ADDENDUM NO. 1

SCADA Improvements at the North Wastewater Treatment Plant

January 31, 2024

SHEET
7
20-E1.01

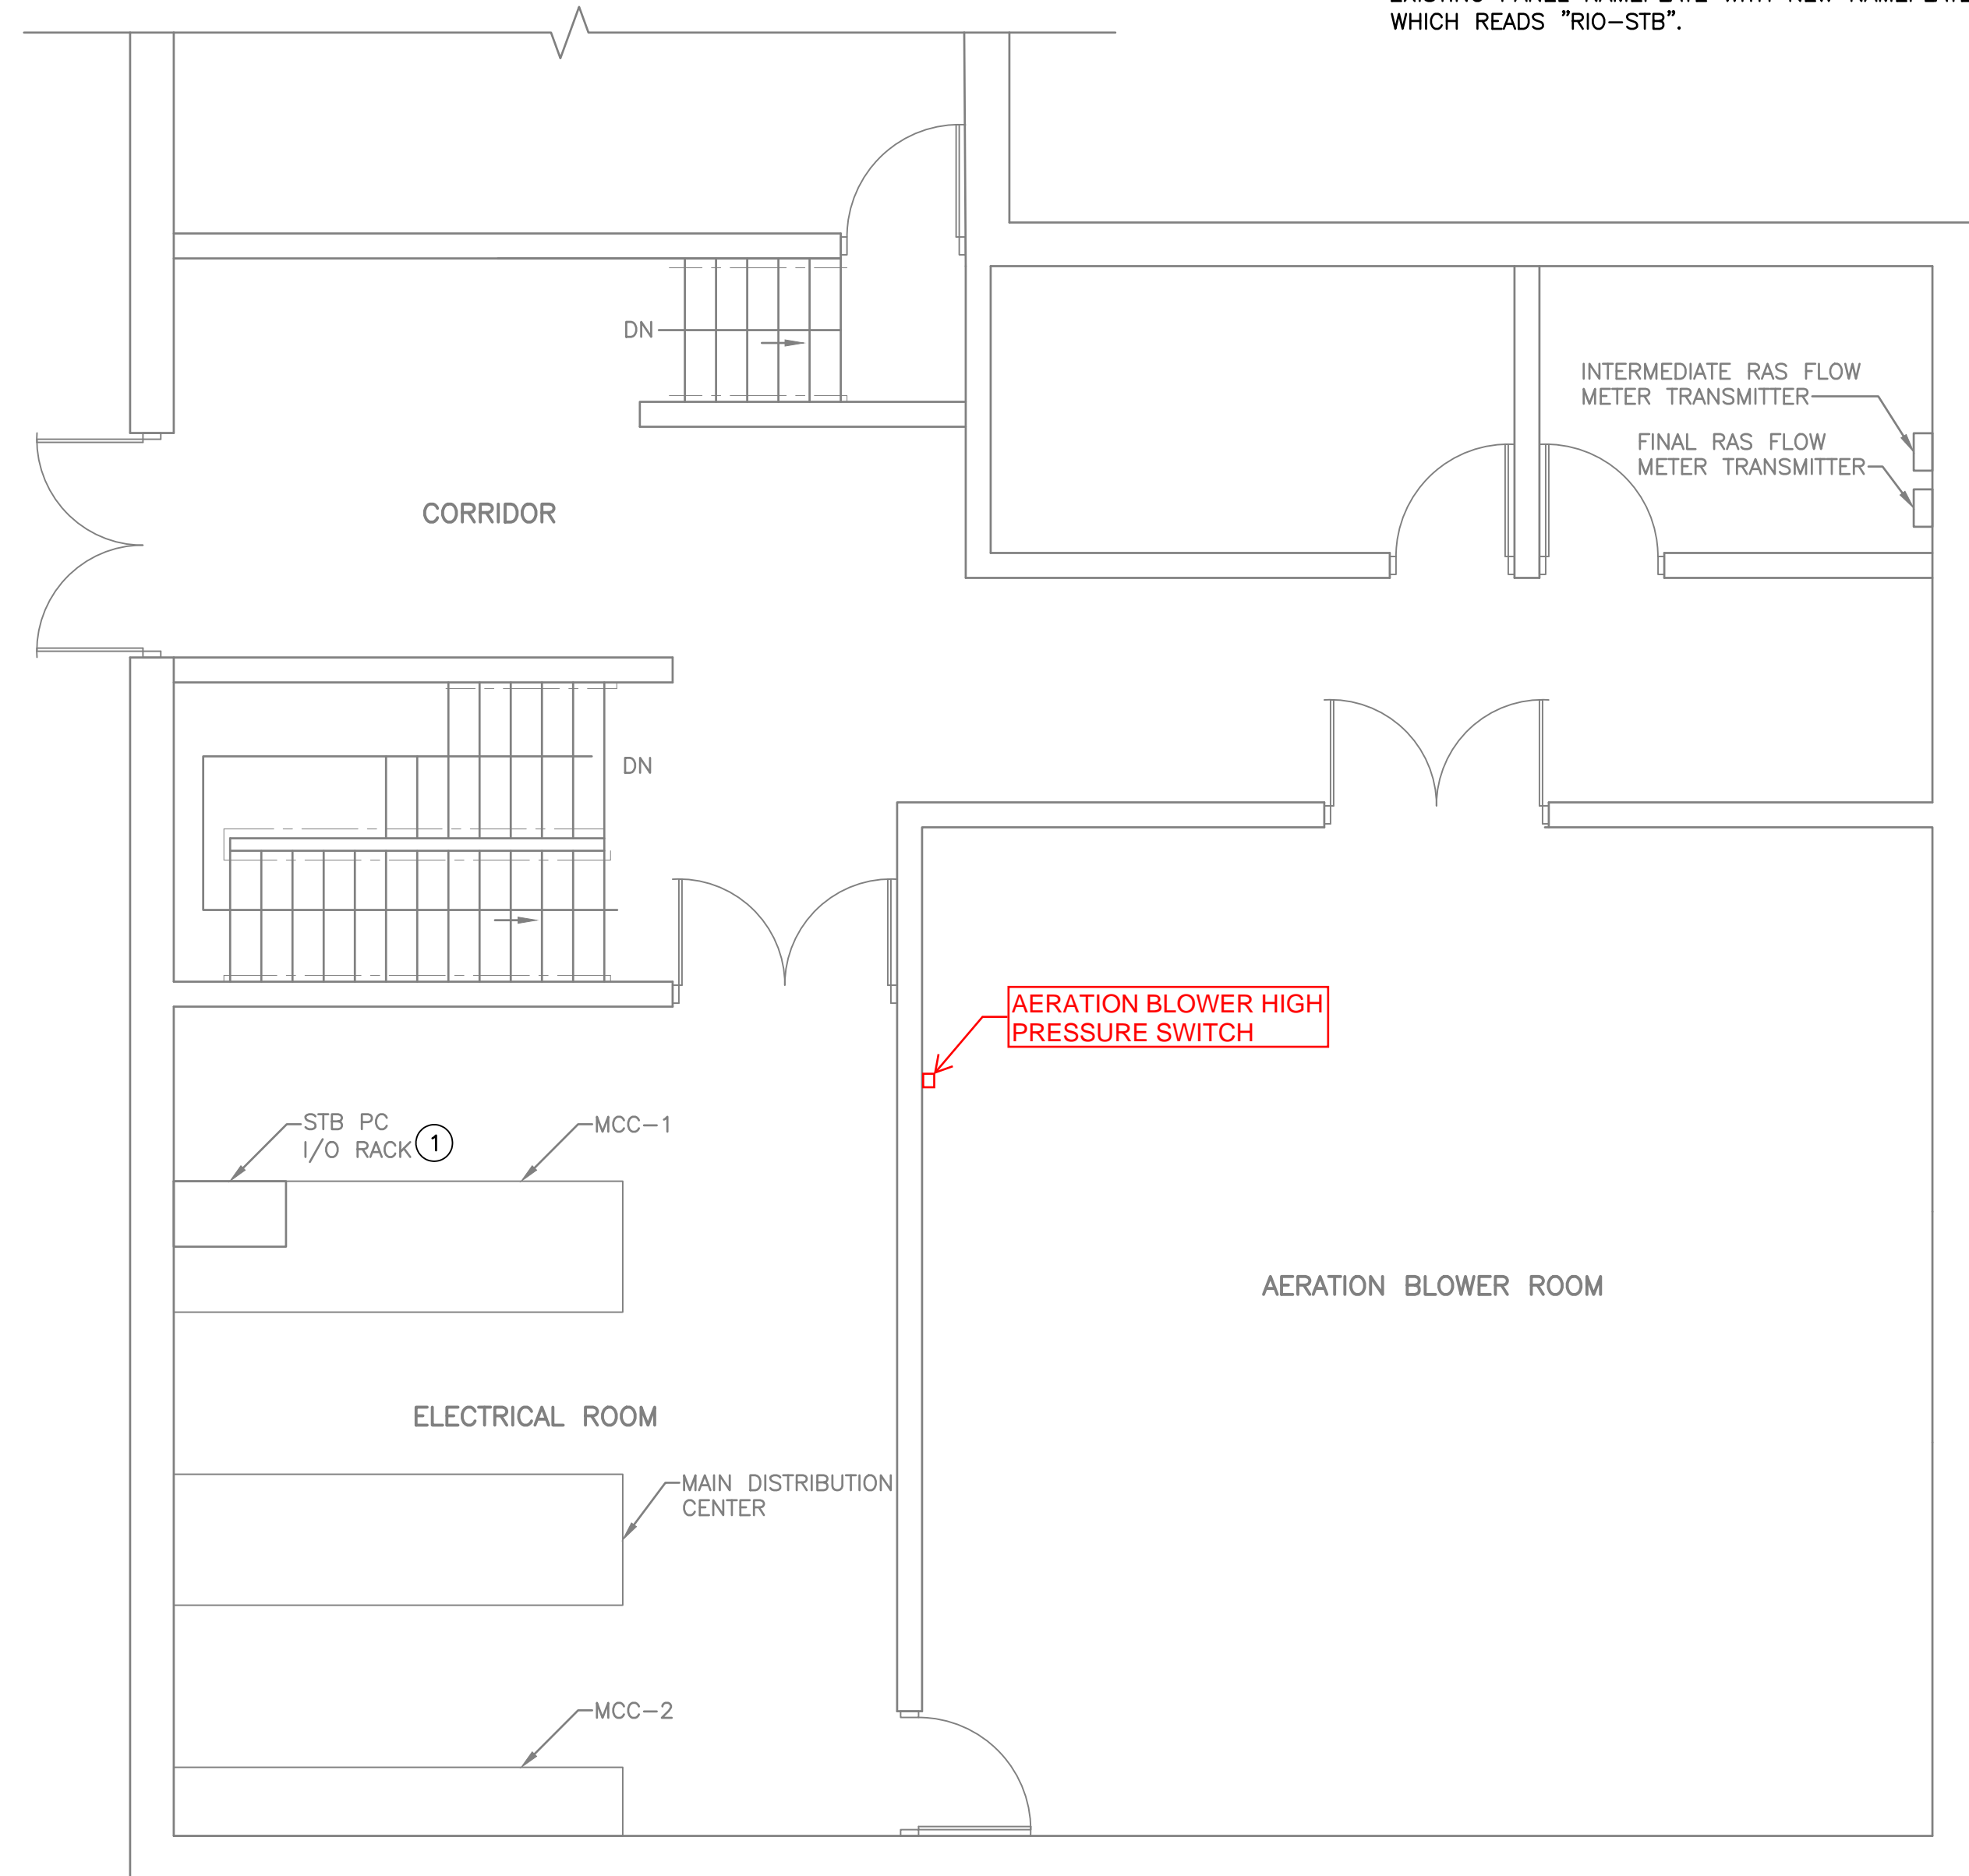
Correction #4

DRAWING 20-E1.01:

Replace entire sheet with the attached revised sheet.
